Well Name: SHERMAN EDWARD	Well Location: T29N / R5W / SEC 3 / SWSW / 36.74925 / -107.35109	County or Parish/State: RIO ARRIBA / NM
Well Number: 2	Type of Well: CONVENTIONAL GAS WELL	Allottee or Tribe Name:
Lease Number: NMNM23048	Unit or CA Name:	Unit or CA Number:
US Well Number: 300392124600C1	Operator: DUGAN PRODUCTION CORPORATION

Notice of Intent

Sundry ID: 2814609

Attachment to notice of Intention to Abandon

## Sherman Edward #2

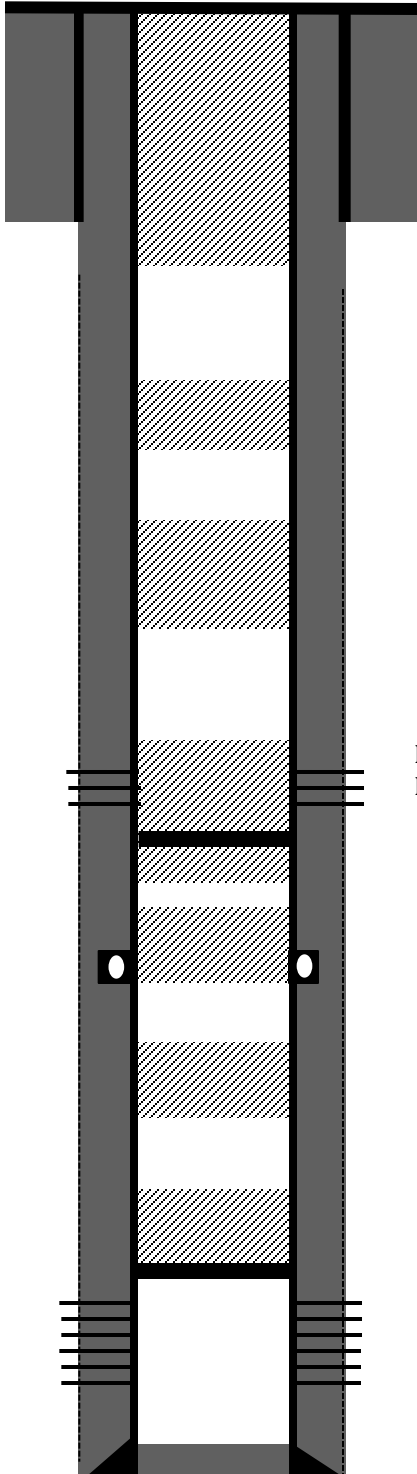
1. Plugging operations authorized are subject to the attached "General Requirements for Permanent Abandonment of Wells on Federal and Indian Lease."
2. The following modifications to your plugging program are to be made:
  - a. Modify Plug 2 bottom of cement to 4489' to account for the BLM geologist's pick for the Chacra at 4439'.
  - b. Modify Plug 4 top of cement to 3110' to account for the BLM geologist's pick for the Fruitland at 3210'.
  - c. Modify Plug 6 top of cement to 730' to account for the BLM geologist's pick for the Nacimiento at 730'.
3. Farmington Office is to be notified at least 24 hours before the plugging operations commence at (505) 564-7750.

**Remarks:** Please adjust plugs to cover BLM-picked formation tops.

Geologic Formations	Tops	Remarks
Nacimiento	830	Gas
Ojo Alamo	2820	F/W Sands
Kirtland	3008	Gas
Fruitland	3210	Coal, Gas
Pic Cliffs	3520	Gas
Chacra	4439	Gas
Cliffhouse	5578	Gas

Created By	Condition	Condition Date
mkuehling	NMOCD concurs with BLM call on formation tops - Notify NMOCD 24 hours prior to moving on - Monitor string pressures report on subsequent - Submit all logs prior to subsequent	10/3/2024
